MEMORANDUM

SUBJECT: DA2023/0898 - 22 Bligh Crescent SEAFORTH - Demolition works and construction of a dwelling house including swimming pool.

This supplementary memo seeks to amend a typographical and formatting error within the report.

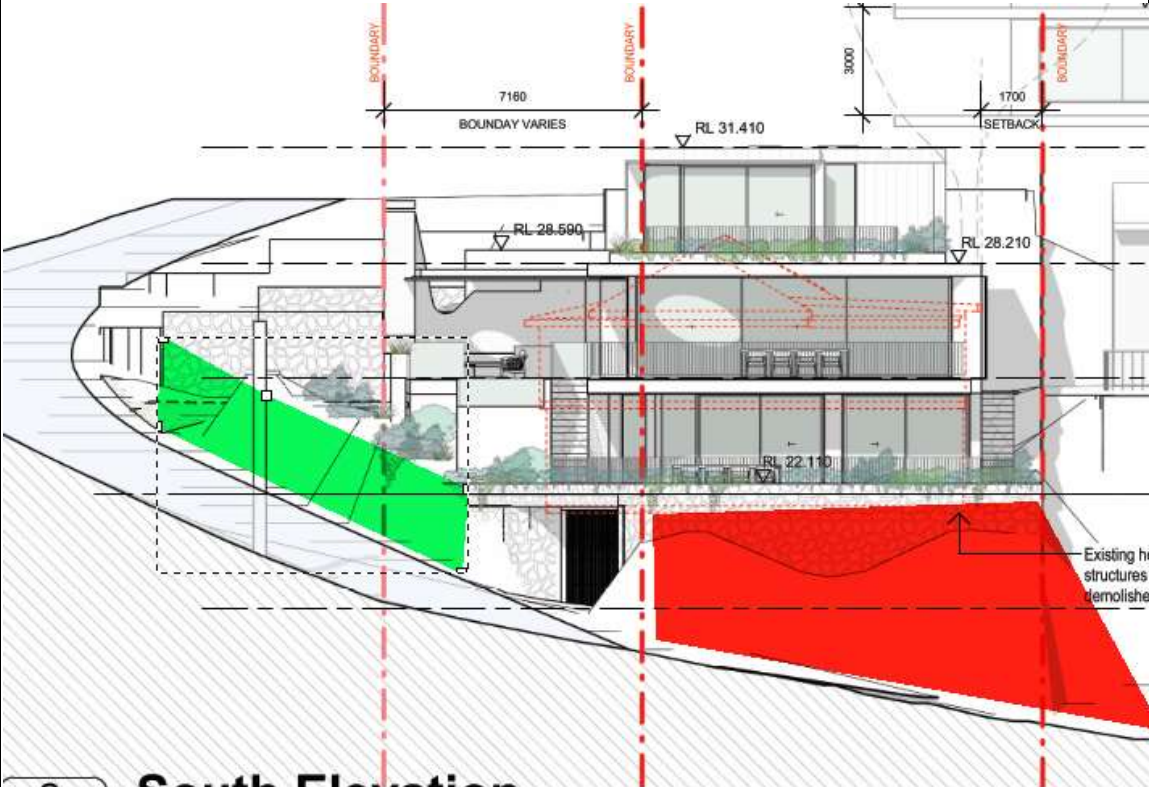
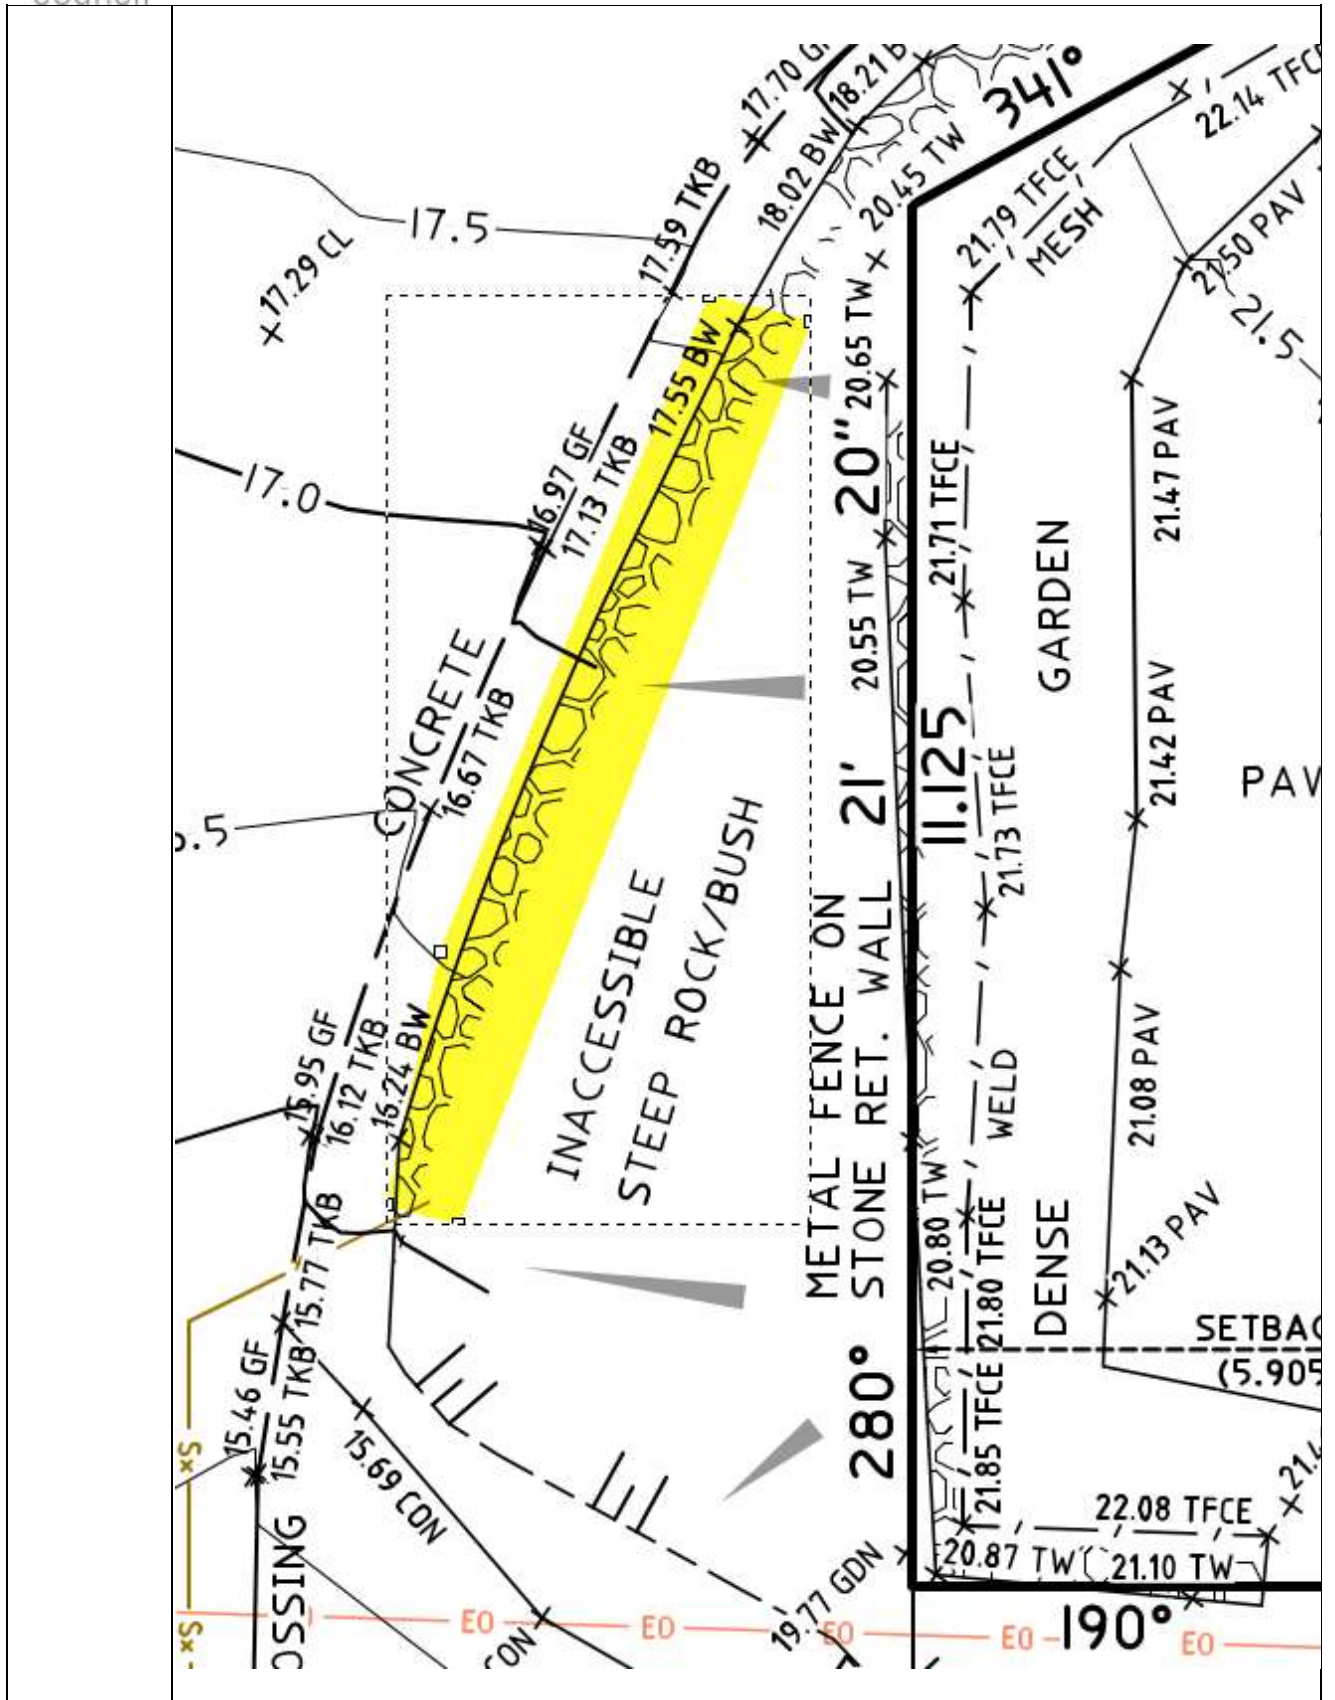
Internal Referral Body	Comments
	<p>Amended Comments 17/11/2023</p> <p>The amended plans (including the "Road Asset Plans" - A400-A406) provide greater certainty regarding treatment of the existing retaining walls in the road reserve. The proposed works (removal of walls, regraded verge and batters and landscaping to address the existing walls are supported.</p> <p>Previous Comments (now redundant@17/11/23):</p> <p>The works impact the existing dry stacked sandstone wall immediately adjacent to the kerb and along the south and western boundary of the property. The proposal includes demolition of part of the wall for driveway access to basement carparking. It is unclear as to the ownership of the retaining wall and whether it has been constructed to create a level building platform for the subject property given it is only located around the subject property or has been built during the land subdivision and construction of the road (circa 1961). It is also not possible to establish the condition of the wall given the extensive private vegetation covering the wall although a inspection of the wall on 11/10/2023 by Council engineer found it to be in reasonable condition. The inspection does however raise concerns regarding the impact of the works on the wall.</p> <p>The geotechnical report does not discuss any specific issues in relation the existing dry stacked stone wall nor its ongoing stability given the basement excavation through the wall and directly behind it.</p> <p>Concerns exist in relation to the proposed works impacting on the existing dry stacked wall and cemented/grouted stone wall uphill of the dry stacked wall. The cement grouted wall would appear to have been added later to retain the front yard of the property and is therefore considered a private structure. It appears the proposed pool is sited adjacent to and/or above the grouted stone wall and excavation of the pool may impact the stability of this wall (area shown in green in image below). No details or consideration appears to have been given to this impact.</p> <p>The excavation for the basement to the south of the driveway entry (and along the southern boundary) will result in a very thin volume of fill between the existing dry stacked stone wall and may result in instability during and after construction. No details or consideration appears to have been given to this impact.</p> <p>The embankment adjacent to the southern boundary (shown in red in image below) is an earth embankment. The survey appears incorrect where it depicts a wall behind the kerb. The FFL of the basement is some 2m above the road level on this frontage and no details are provided as to the treatment of this embankment. The basement constructed to the boundary will need to ensure adequate footings are provided and no reliance is placed on the road reserve embankment for support.</p> <p>The location of the driveway and its design limits the available sight distance which could be improved with changes to the design.</p>

Internal Referral Body	Comments
	<p>Council's Development Engineering Team to require an Application for Infrastructure Works on Council Roadway to ensure the design and adjustments to the dry stacked sandstone retaining wall and other retaining walls associated with the driveway access is considered. The application for Infrastructure Works shall also address the proposed stepping stones across verge to ensure these works comply with Council standards. A Council approval is to be submitted to the Certifier prior to the issue of the Construction Certificate.</p> <p>Council's Property Team should receive a referral to advise whether a Road Reserve Consent is required in accordance with the former Manly Council Policy for the structural works across the verge. The demolition of the existing garage is noted and may require the cancellation of the existing road reserve lease.</p> <p>The proposed stone wall with letterbox is not supported given the extent of encroachment into the public road reserve and fencing off/alienating the area for private use. The proposed wall should be removed and replaced with a letter box not more than 600x600mm</p> <p>Development Engineering to require the submission of a report on the condition of the retaining wall and a photographic dilapidation report is to be completed and submitted for Council assessment and approval (following removal of vegetation) prior to the issuing of the construction certificate to ensure the proposed works are unlikely to impact the stability of the wall. A Council approval is to be submitted to the Certifier prior to the issue of the Construction Certificate. A bond for insure against damage the retaining wall shall be required in the amount of \$????,???</p> <p>Accordingly, it is not possible to support the proposed works given the lack of detail pertaining to the retaining walls on the road reserve and consideration of the construction methodology impacting on the walls. The landscaping plans identify the need for planting on the road reserve but insufficient details are provided including any "structural" landscaping to achieve the desired outcome.</p>
